Item ID: D412-664-205

Item Name: Crosstube, Low Narrow Aft, 412CF

DESIGN	RF	<b>DART AEROSPACE LTD</b>	
DRAWN	RF	HAWKESBURY, ONTARIO, CANADA	
CHECKED	RF	DRAWING NO.	REV. D
MFG. APPR.	RF	D412-664-245	SHEET 2 OF 4
APPROVED	RF	TITLE	SCALE
DE APPR.	RF	CROSSTUBE ASS'Y (412 LOW-N AFT)	NTS
DATE	09.09.30	COPYRIGHT © 2005 BY DART AEROSPACE LTD THIS DOCUMENT IS PRIVATE AND CONFIDENTIAL, AND IS SUPPLIED ON THE EXPRESS CONDITION THAT IT IS NOT TO BE USED FOR ANY PURPOSE OR COMED OR COMMUNICATED TO ANY OTHER PERSON WITHOUT WRITTEN PERMISSION FROM DART AEROSPACE LTD.

DRAWING NO. D412-664-245	TITLE CROSSTUBE ASS'Y (412 LOW-N AFT)	REV. D	<b>DART AEROSPACE LTD ENGINEERING ORDER</b>		D.E.O. NO. D412-664-245-D-1	SHEET NO. SHEET 1 OF 2	SCALE NTS
DRAWN <i>q</i>	CHECKED <i>SC</i>	MFG. APPR. <i>E</i>	APPROVED <i>MD</i>		DE APPR. <i>#</i>		
DATE 11.05.25	DATE 11.05.31	DATE 11.05.31	DATE 11/05/31		DATE 11.05.31

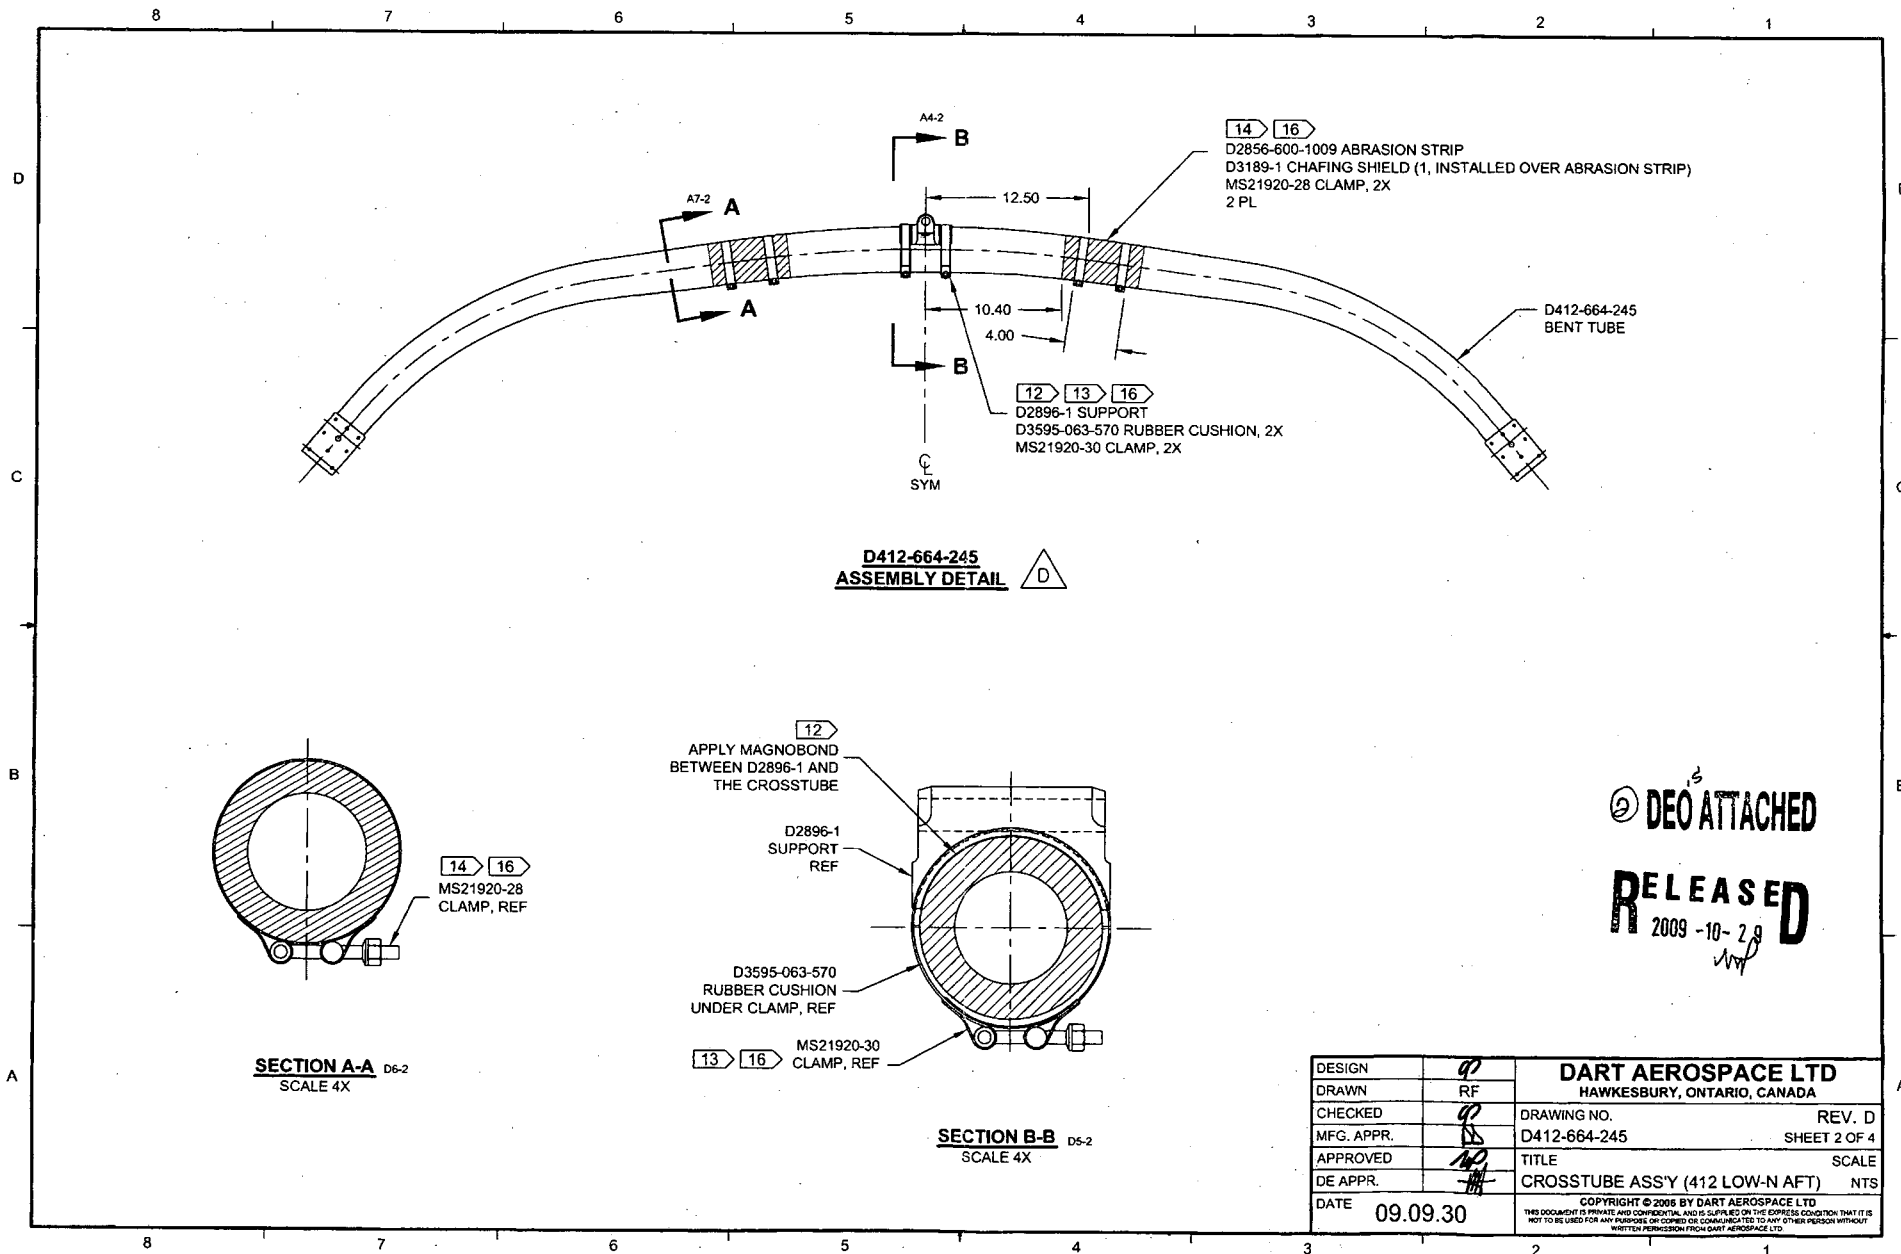
D	REVISE GENERAL NOTES; UPDATE TO CURRENT STANDARDS; RELOCATED FLAG #6 PER PAR 08-046 (ZN A7-3)	RF	09.09.30
C	CHG RIVET AND RUBBER CUSHION	CP	07.03.29
B	CHG CUFF AREA, CHG RUBBER CUSHION	CP	07.03.01
A	NEW ISSUE	CP	06.12.01
REV.	DESCRIPTION	BY	DATE
DESIGN	RF	DART AEROSPACE LTD HAWKESBURY, ONTARIO, CANADA	
DRAWN	RF	DRAWING NO. REV. D	
CHECKED	RF	D412-664-245	SHEET 1 OF 4
MFG. APPR.	RF	TITLE	SCALE
APPROVED	RF	CROSSTUBE ASS'Y (412 LOW-N AFT)	NTS
DE APPR.	RF	COPYRIGHT © 2006 BY DART AEROSPACE LTD THIS DOCUMENT IS PRIVATE AND CONFIDENTIAL AND IS SUPPLIED ON THE EXPRESS CONDITION THAT IT IS NOT TO BE USED FOR ANY PURPOSE OR COPIED OR COMMUNICATED TO ANY OTHER PERSON WITHOUT WRITTEN PERMISSION FROM DART AEROSPACE LTD.	
DATE	09.09.30

**SECTION A-A**  
CHAFING SHIELD DETAIL  
VIEW ROTATED, NOT TO SCALE

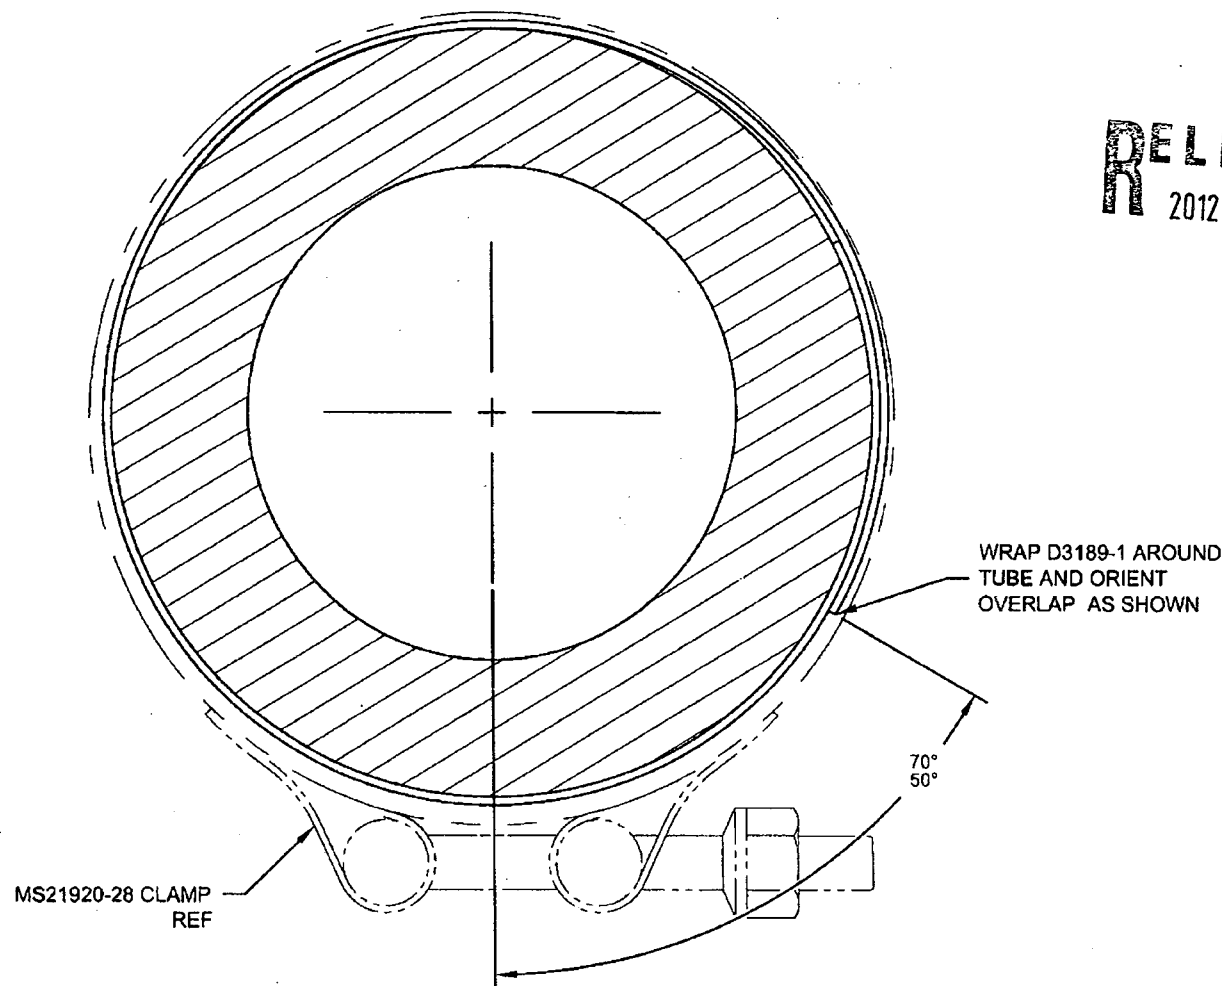
NOTE 14 AND 16 ON SHEET 1 IS AMENDED AS FOLLOWS:
